SUNDOWN SOLAR FARM

Submissions Report

Prepared for Recurrent Energy
June 2025

Figure 4.2 **Railway level crossings on the haulage route**

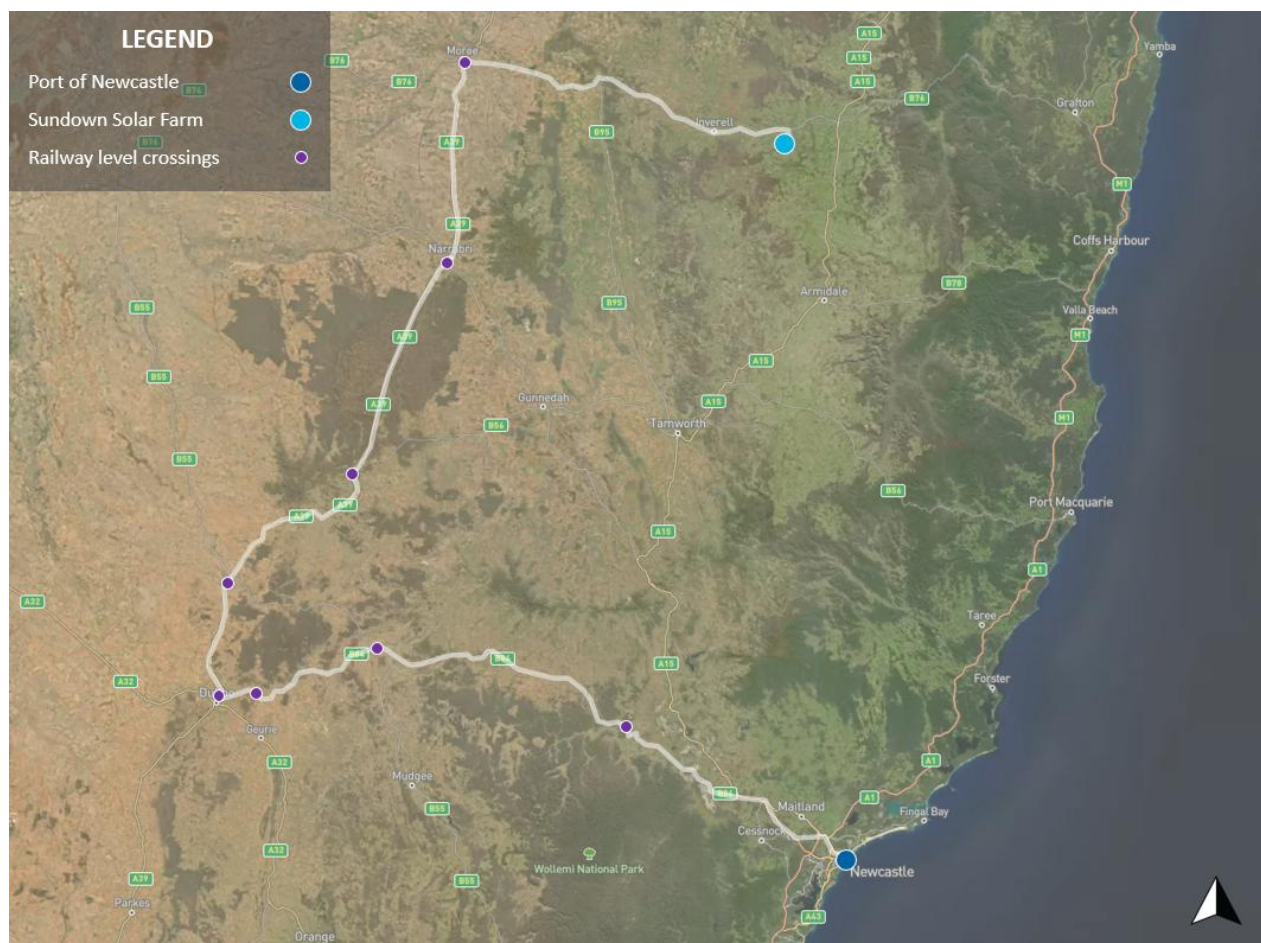
Provide an over-size over-mass vehicle (OSOM) assessment.

As outlined in the OSOM assessment eight railway level crossings have been identified along the OSOM haulage route from Port of Newcastle to the site, as shown in Figure 4.2 and Table 4.2.

As shown in Table 4.2, two railway level crossings have been identified (at Sullivan Street, Dunedoo and Alice Street, Moree) where the OSOM vehicle may potentially travel at speeds lower than 35 km/h. The Australian Rail Track Corporation (ARTC) will be contacted prior to the OSOM travelling across these railway crossings.

Sundown Solar Farm
Submissions Report
Figure 4.3

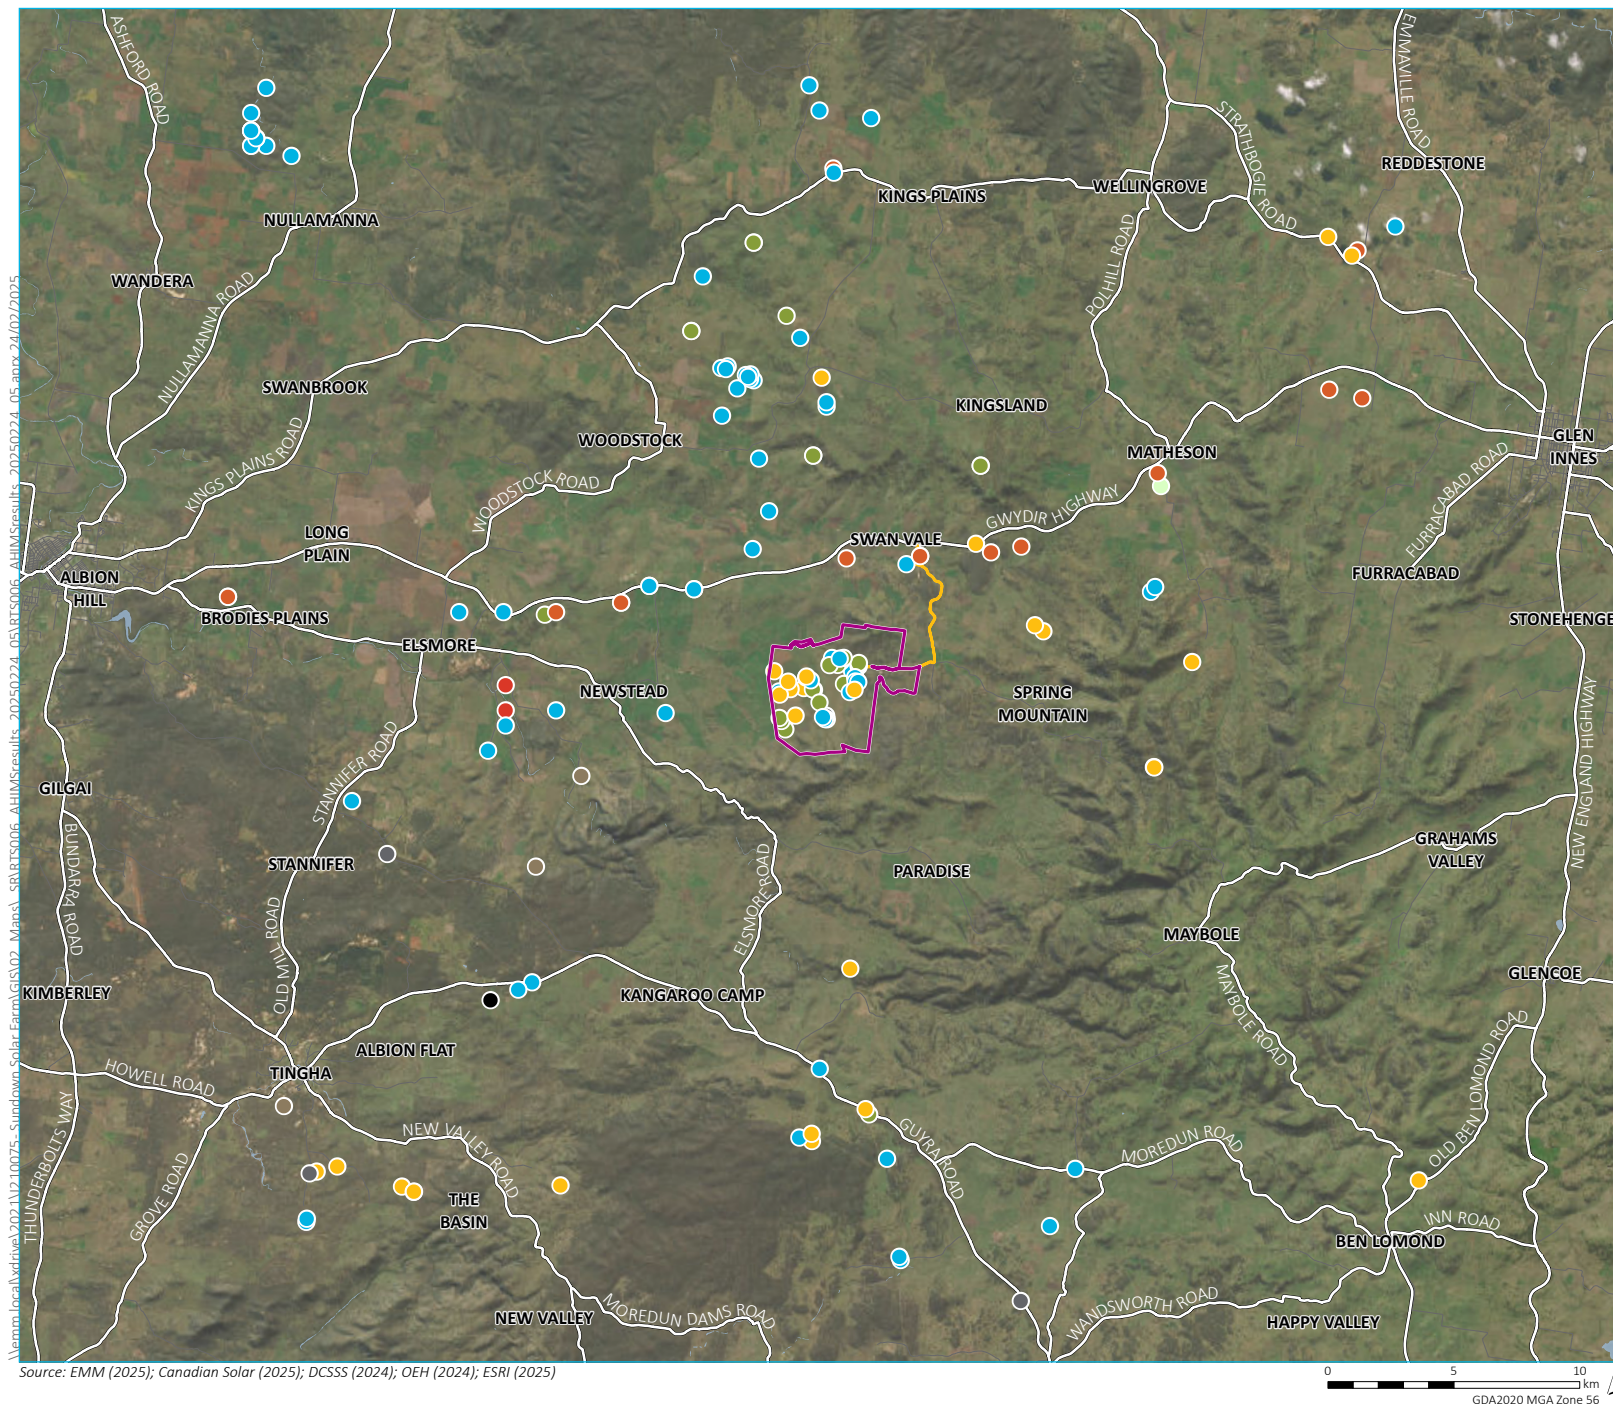
Please provide an updated Aboriginal Heritage Information Management System (AHIMS) search, as the AHIMS search is greater than 12 months old at the time of submission.

All 50 sites are shown in Figure 4.3.

The AHIMS reference numbers of the 38 project-related AHIMS are detailed in Table 4.3 and Figure 4.3.

Sundown Solar Farm
Submissions Report
Figure 4.4

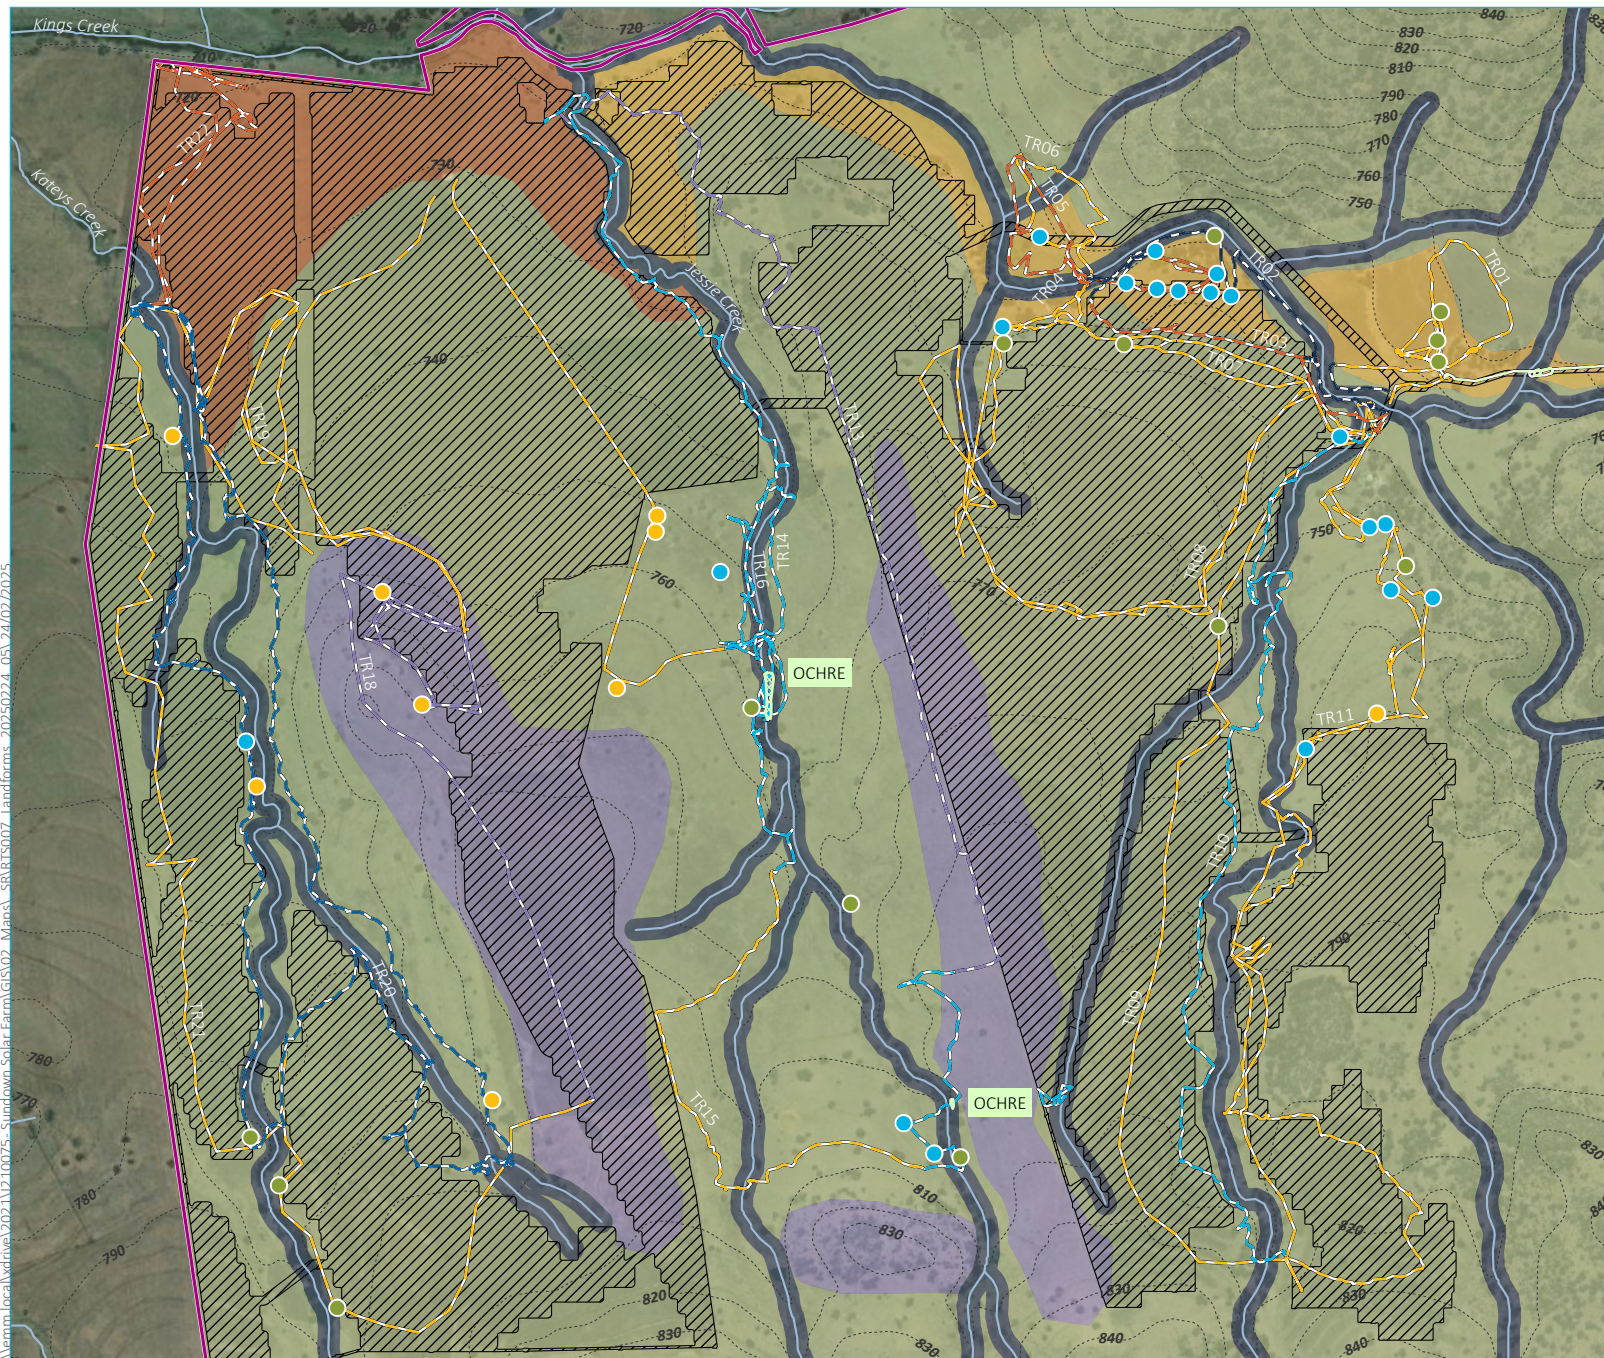
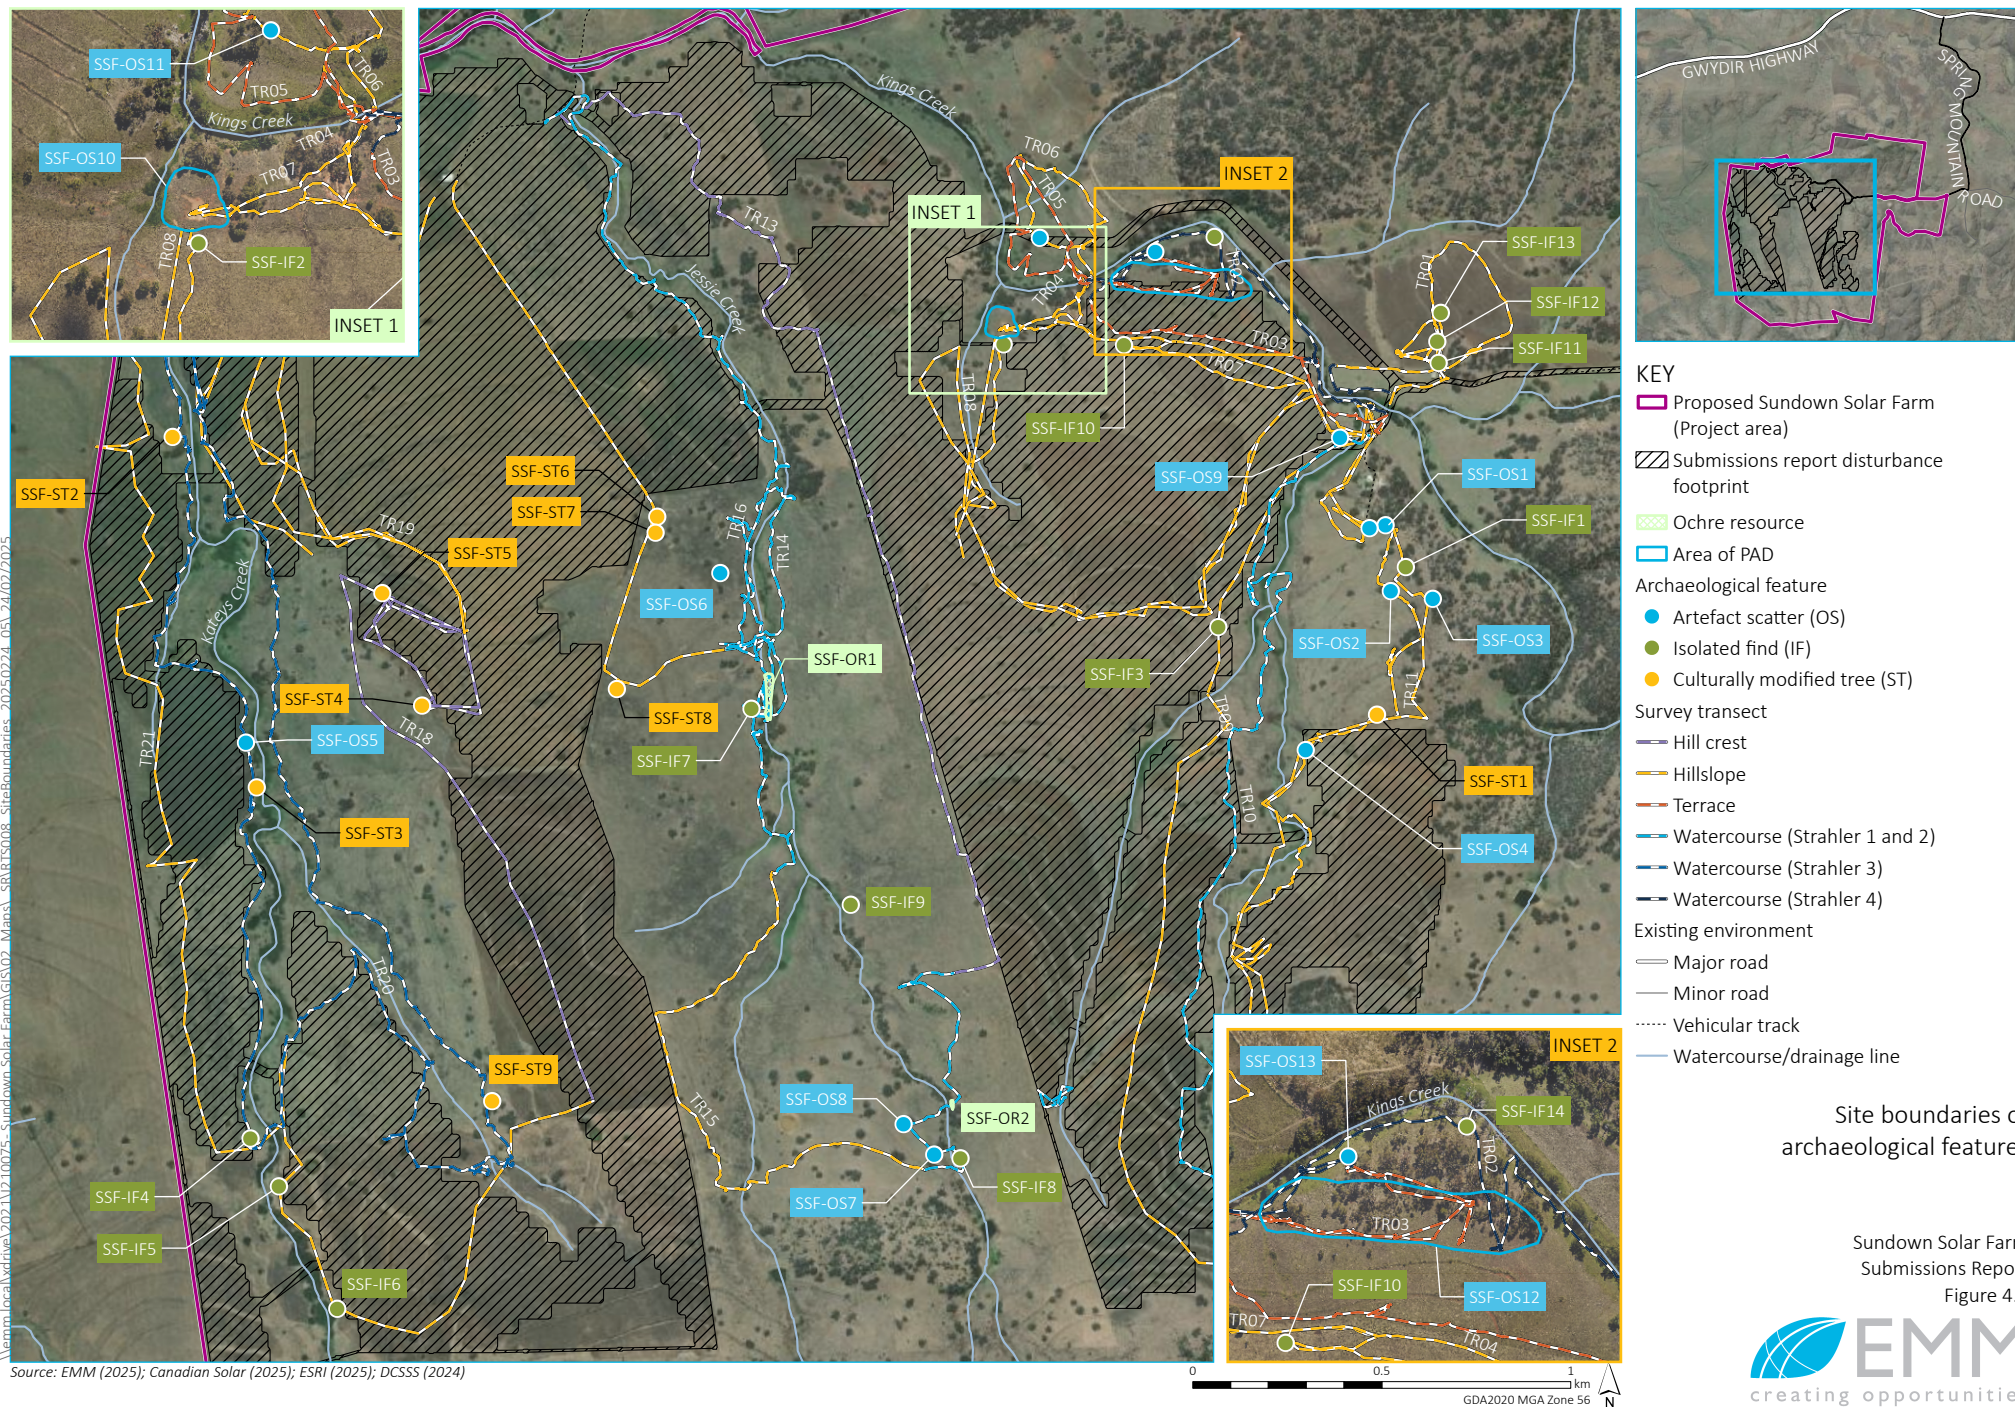
Please provide additional mapping to clarify the survey transects and their relationship with the project boundary, project infrastructure, PV arrays, and landforms.

Please update mapping to include site boundaries of artefact scatters.

The landforms relating to the Sundown Solar Farm are described in sections 5, 7.5 and 10 of the ACHAR and are presented in Figure 4.4. This includes the project boundary, access road, conceptual site layout and is overlaid with the pedestrian survey transects and targeted access road survey.

The site boundaries of the two large artefact scatters (SSF-OS10 and SSF-OS12) are presented in Figure 4.5. All other artefact scatters comprised only 2 to 4 artefacts and were constrained to an area of 5 m² or less. The indicative extent of the two ochre resources is also shown.
